**From:** Arkerson, Jim [mailto:Jim.Arkerson@fpl.com]  
**Sent:** Wednesday, July 30, 2008 12:50 PM  
**To:** Lein, Jerry R.  
**Cc:** Scovill, Scott; Marchese, Joe; Rausch, Dick; Mayers, D J; Givens, Phillip; Talmud, Fred; Sowry, Jim; Oberg, Perry; Ashtabula  
**Subject:** RE: FPLE Ashtabula Wind Structures Moves

87 PU-08-32 Filed: 7/30/2008 Pages: 12  
Structure Relocation Summary and Commission  
Approval of Requested Structure Changes

As the design engineering firm and on behalf of FPL Energy, I am respectfully submitting the attached Change Summary drawings associated with the Ashtabula Wind 230kV transmission line, as well as an updated copy of the plan and profile drawings. This represents proposed changes to the transmission line alignment from what was submitted at the PSC Hearing.

**ASHTABULA WIND, LLC 230KV LINE**

# STRUCTURE LAYOUT SKETCH

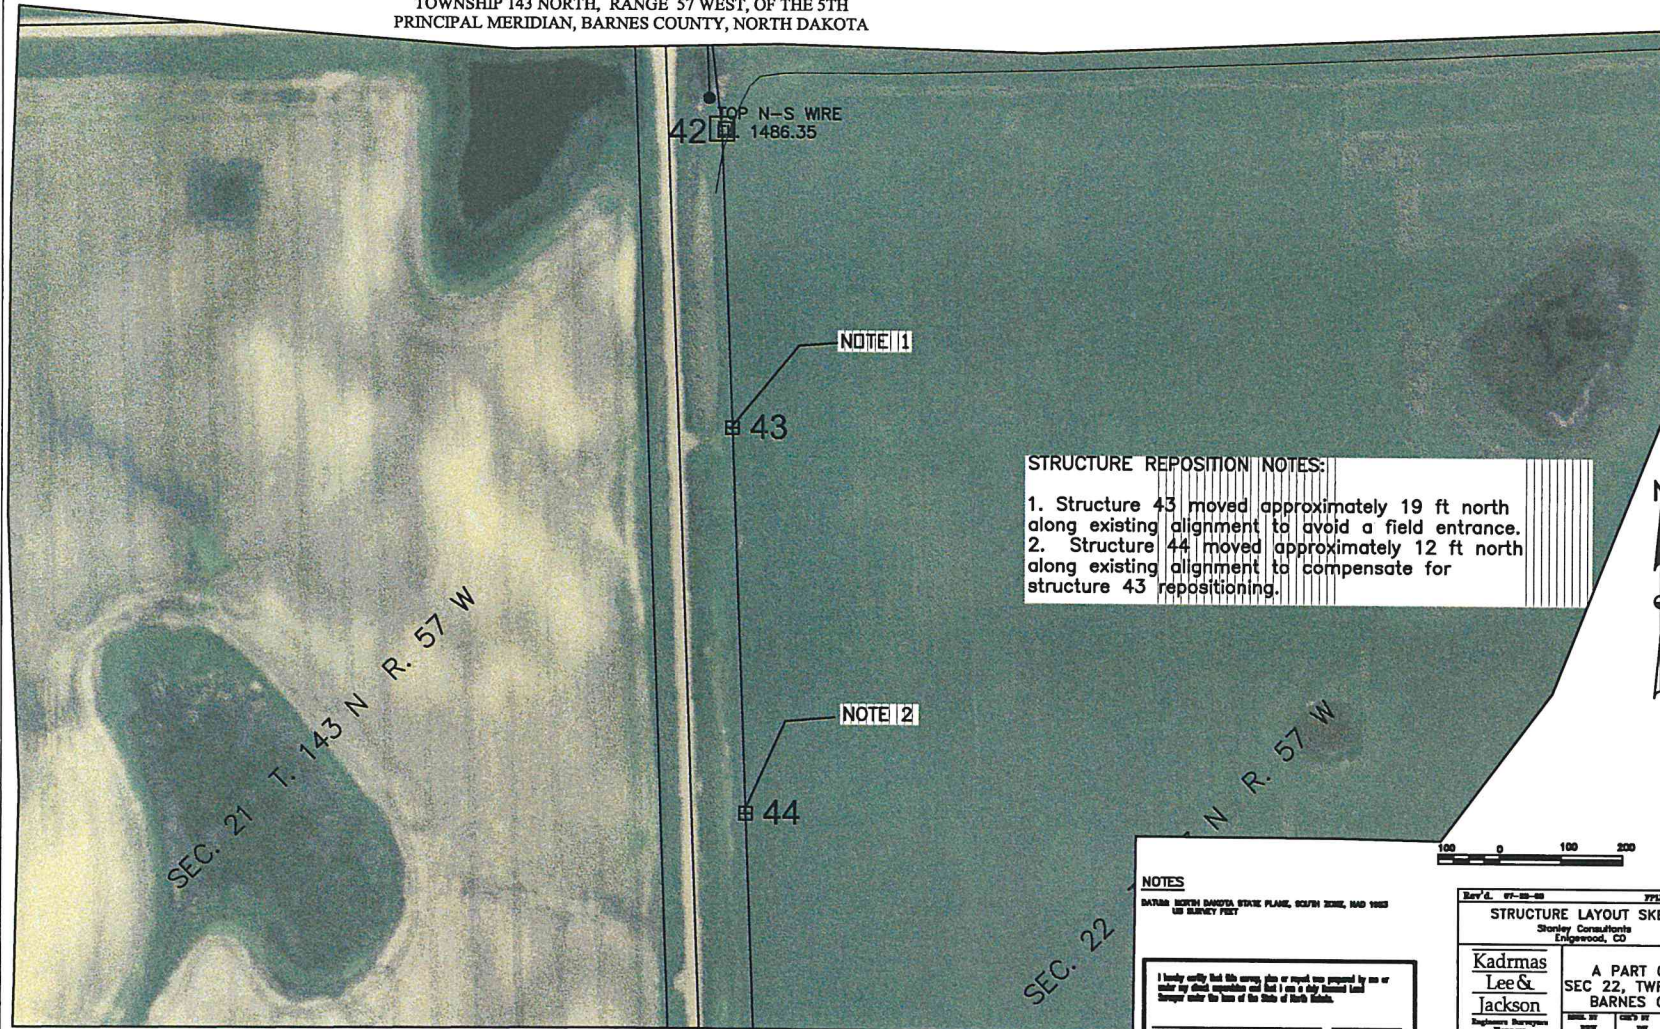
Sheet 1                      Structures 43 & 44                      These two (2) structures was moved 19' and 12' south in order to better accommodate land owner concerns regarding farming activities and field access

STRUCTURE REPOSITION NOTES:  
1. Structure 43 moved approximately 19 ft north along existing alignment to avoid a field entrance.  
2. Structure 44 moved approximately 12 ft north along existing alignment to compensate for structure 43 repositioning.

Please accept my sincere apologies. Sheet 1 explanation should read that "These two (2) structures were moved 19' and 12' north (not south).

# STRUCTURE LAYOUT SKETCH

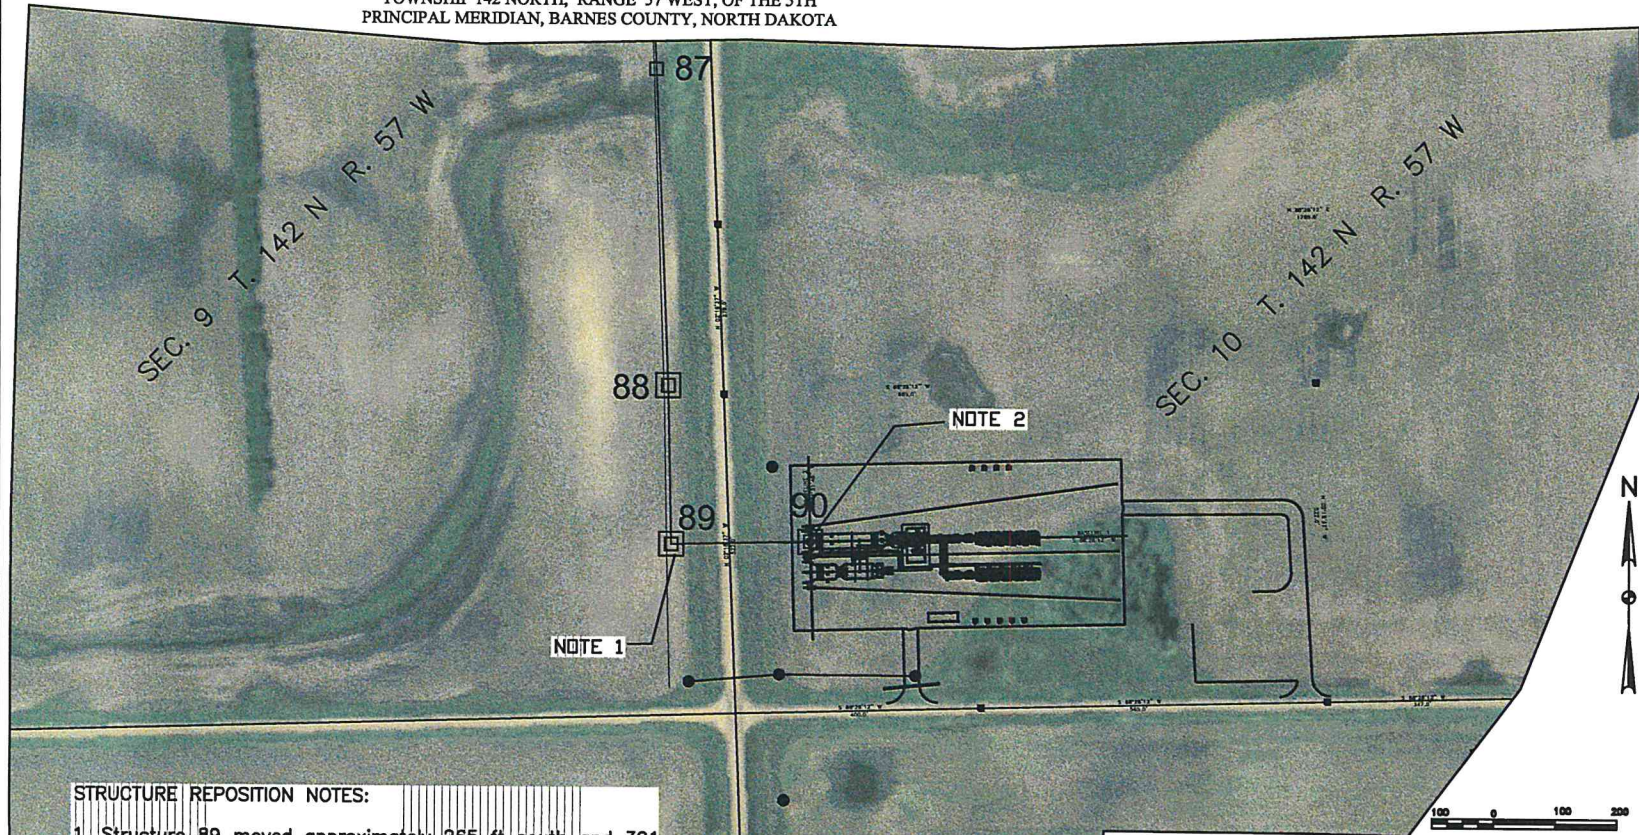
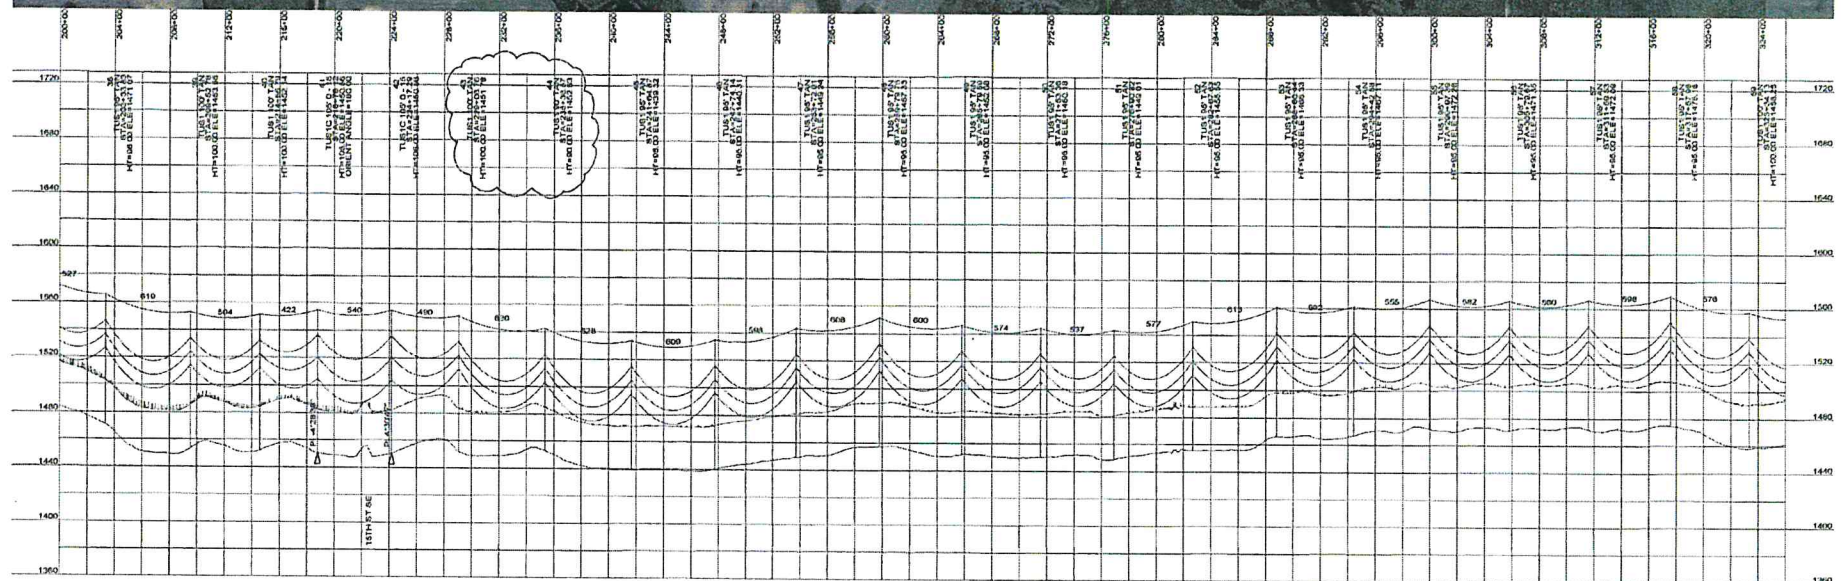
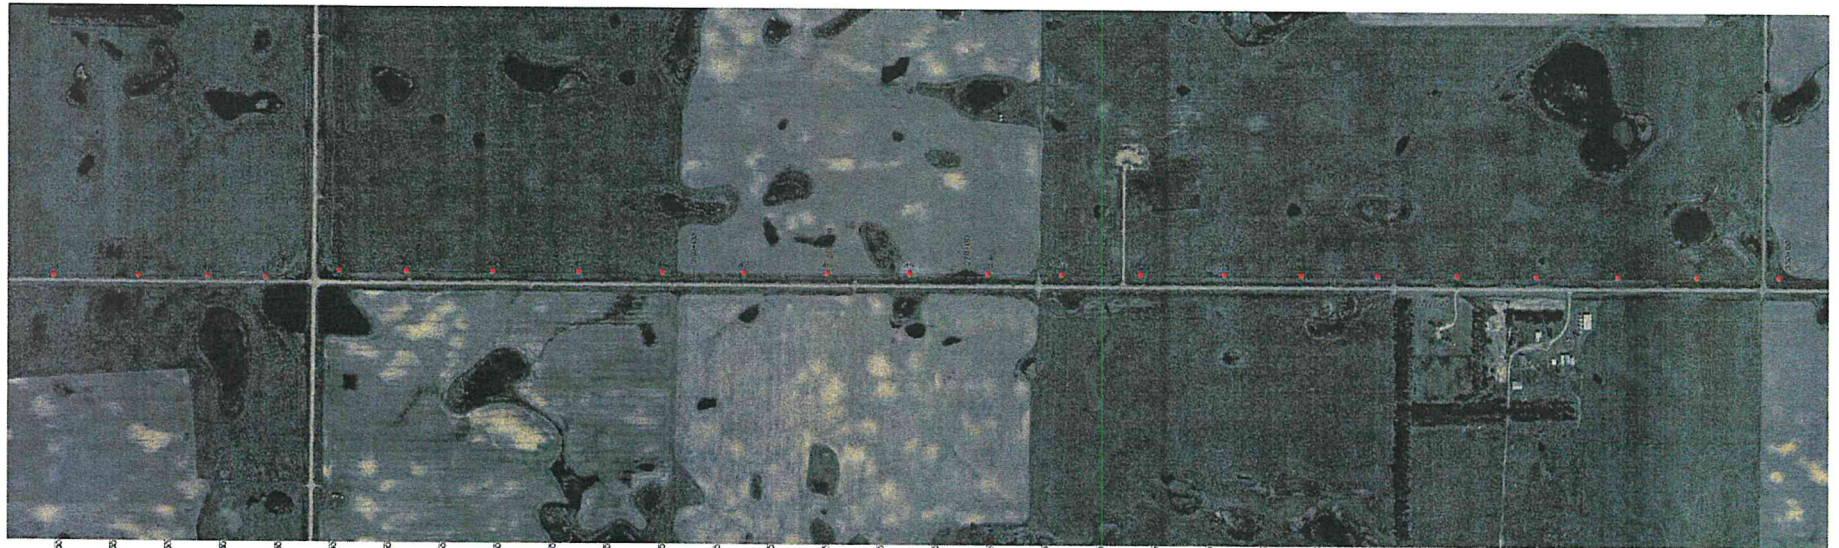
Sheet 2                      Structures 88 - 89                      These two (2) structures were moved based on new information regarding the physical location of the Barnes Substation.

1. Structure 89 moved approximately 265 ft south and 301 ft west of previous location to correct a layout error and align with the Barnes Substation deadend (Structure 90).
2. The total number of structures (90) still agrees with the hearing record.

070775 Sheet 1 of 1		<b>FPL ENERGY - ASHTABULA WIND ENERGY TRANSMISSION LINE</b> <b>OVERALL SITE PLAN</b> BARNES COUNTY, NORTH DAKOTA

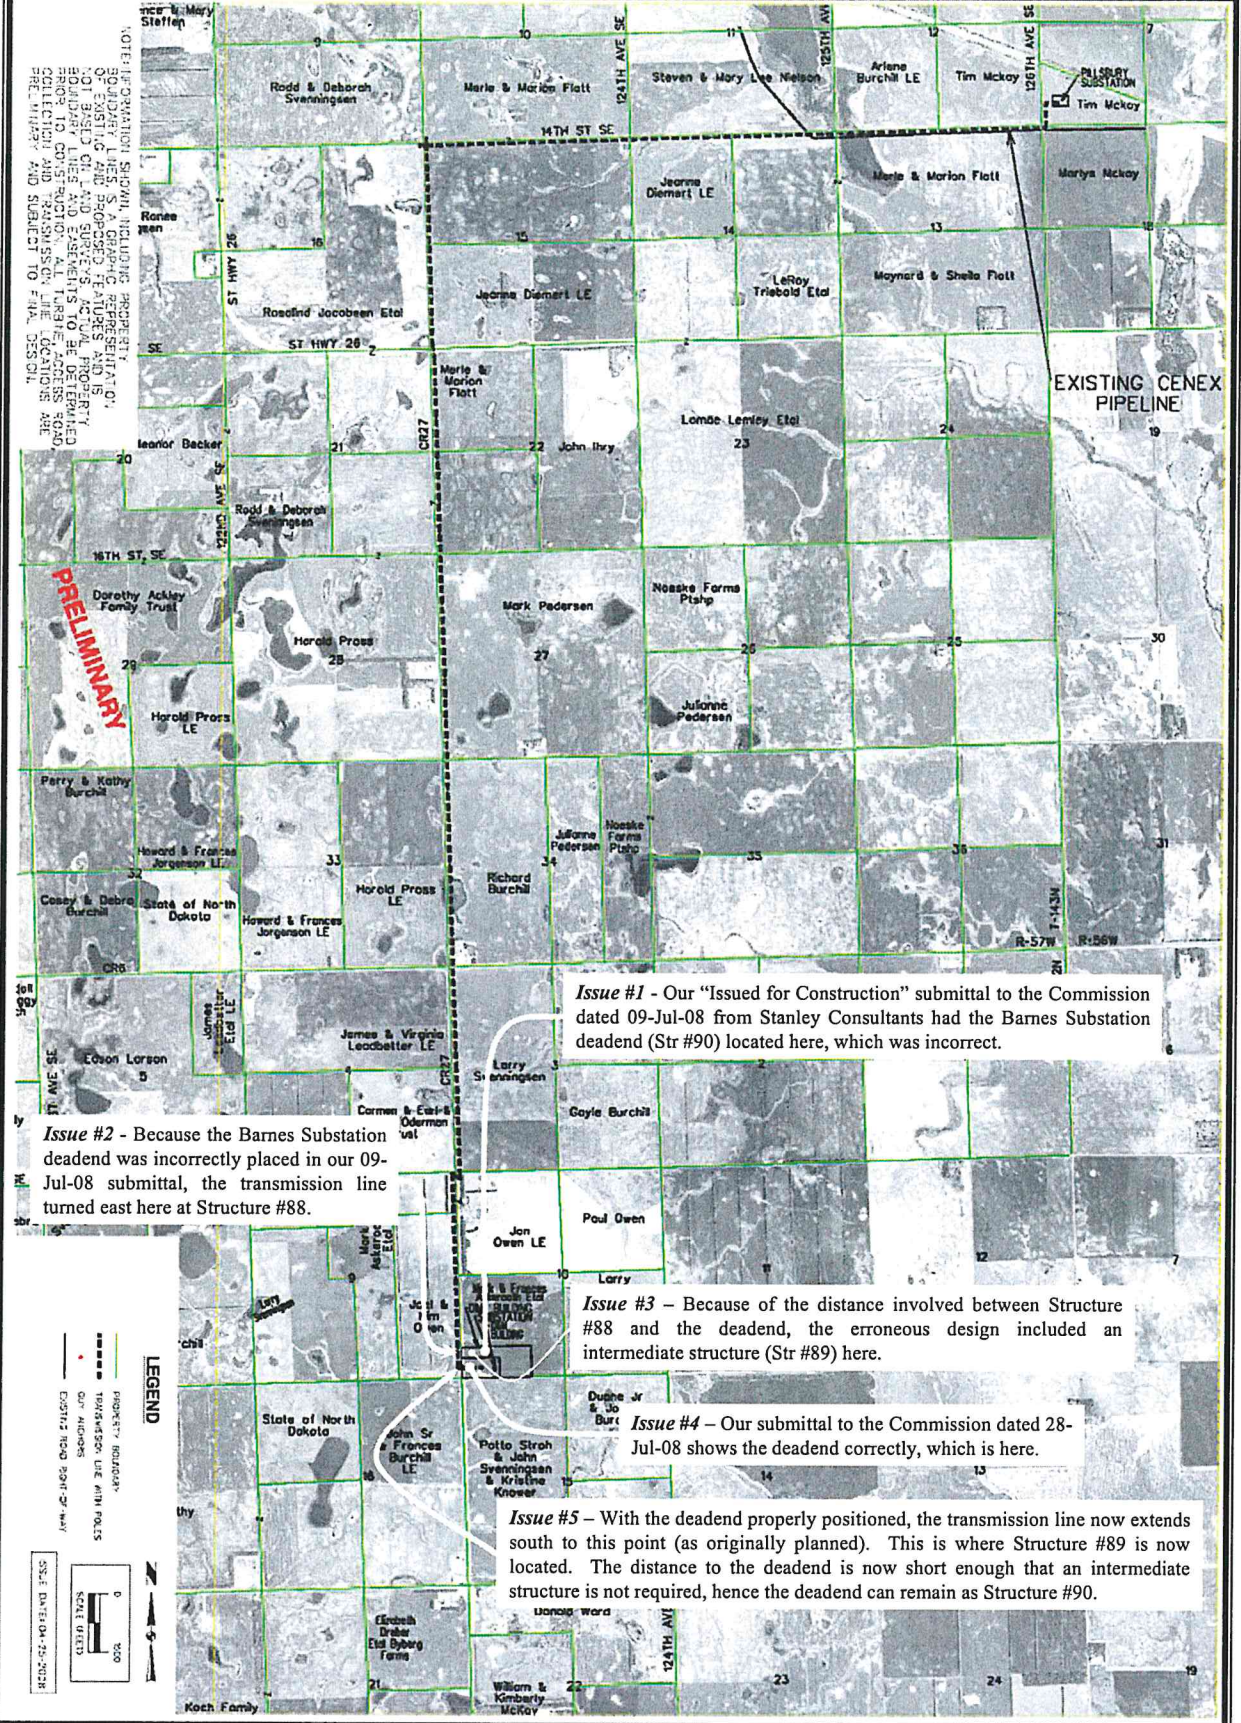
**Issue #1** - Our "Issued for Construction" submittal to the Commission dated 09-Jul-08 from Stanley Consultants had the Barnes Substation deadend (Str #90) located here, which was incorrect.

**Issue #2** - Because the Barnes Substation deadend was incorrectly placed in our 09-Jul-08 submittal, the transmission line turned east here at Structure #88.

**Issue #3** - Because of the distance involved between Structure #88 and the deadend, the erroneous design included an intermediate structure (Str #89) here.

**Issue #4** - Our submittal to the Commission dated 28-Jul-08 shows the deadend correctly, which is here.

**Issue #5** - With the deadend properly positioned, the transmission line now extends south to this point (as originally planned). This is where Structure #89 is now located. The distance to the deadend is now short enough that an intermediate structure is not required, hence the deadend can remain as Structure #90.
